CWSP SYSTEM HARDENING FIELD SCOPING DOCUMENT

PM: ██████████	Project Name: SH - BUCKS CREEK 1101 CB	
Notification: ██████████	Region: Northern	City: Rock Creek
Project Manager: ██████████	Division: North Valley	County: Plumas

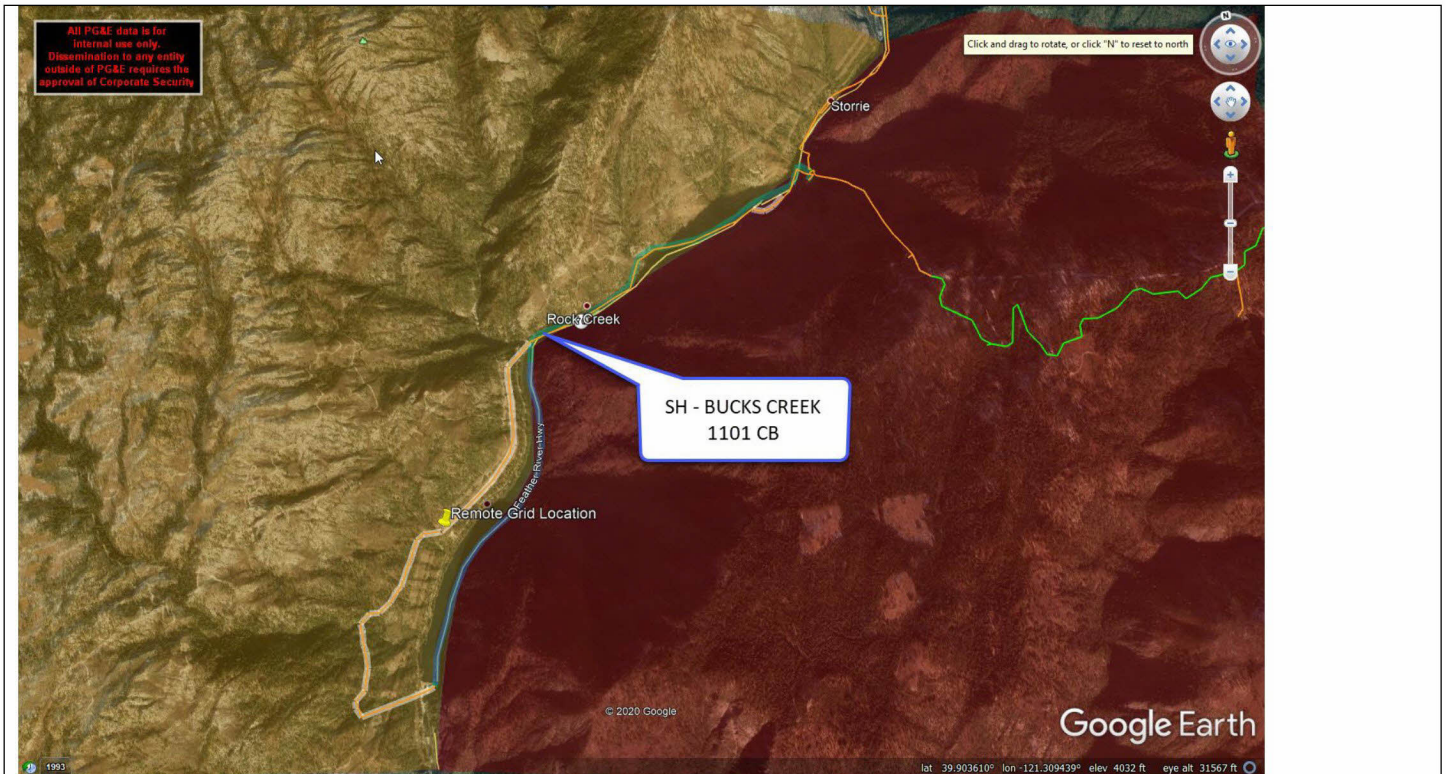
- This area has significant fire history directly impacting the project area. A 20 year look back at area fire history includes, the 56,000 acre Storrie fire (2000), 8,000 acre Poe fire (2001), 1700 acre Highway 70 fire (2001), 50,000 acre Butte Lightning Complex (2008), Canyon Complex (2008), 30,000 acre Chips Fire (2012), 154,000 acre Camp fire (2018) and the 320,000 acre North Complex 2020 all burned within the Feather River Canyon.

- Not all the fires were directly in the project footprint area; however, they show that this area is prone to significant, large fire history due in large part to steep, rugged, inaccessible terrain and periods of strong wind.

- The Feather River drainage is prone to daily diurnal winds and strong north/Diablo wind events at various times of the year, but most notably during the fall period when fuels are at their driest. These conditions have resulted in the area being affected routinely by PSPS events and has also resulted in many large, devastating fires originating in the Feather River drainage.

- A) **Project Area** – Google Earth Image with Circuit and HFTD Tier 2 &3 Overlay

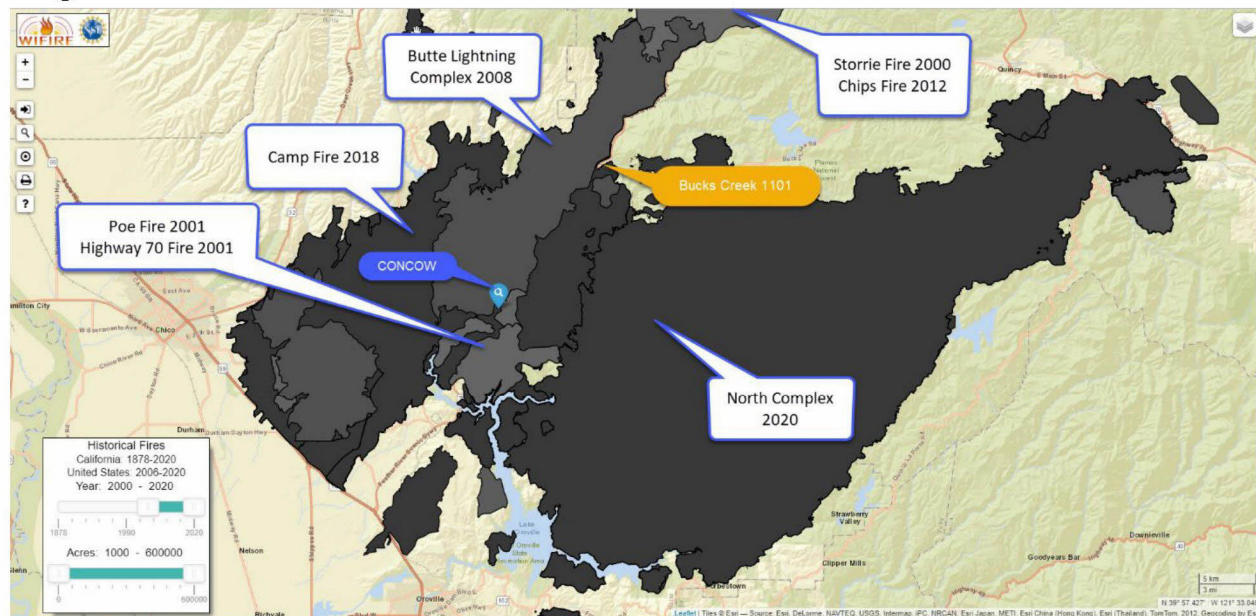
- This project crosses Highway 70 near the Bucks Creek Powerhouse and then parallels the highway for a roughly 2-mile stretch, and then runs along Storrie Rd. paralleling the Feather River on the canyon opposite side of Highway 70. Highway 70 is a main thoroughfare for ingress/egress for emergency responders and to the few residents who live in that direct area; it is also a major route for commerce both by vehicle and railroad.
- If Highway 70 was closed in this area it would make ingress and egress difficult if not impossible for responders and citizens; and, economically be a substantial hit to commerce. There are no alternative routes within the Feather River Canyon.
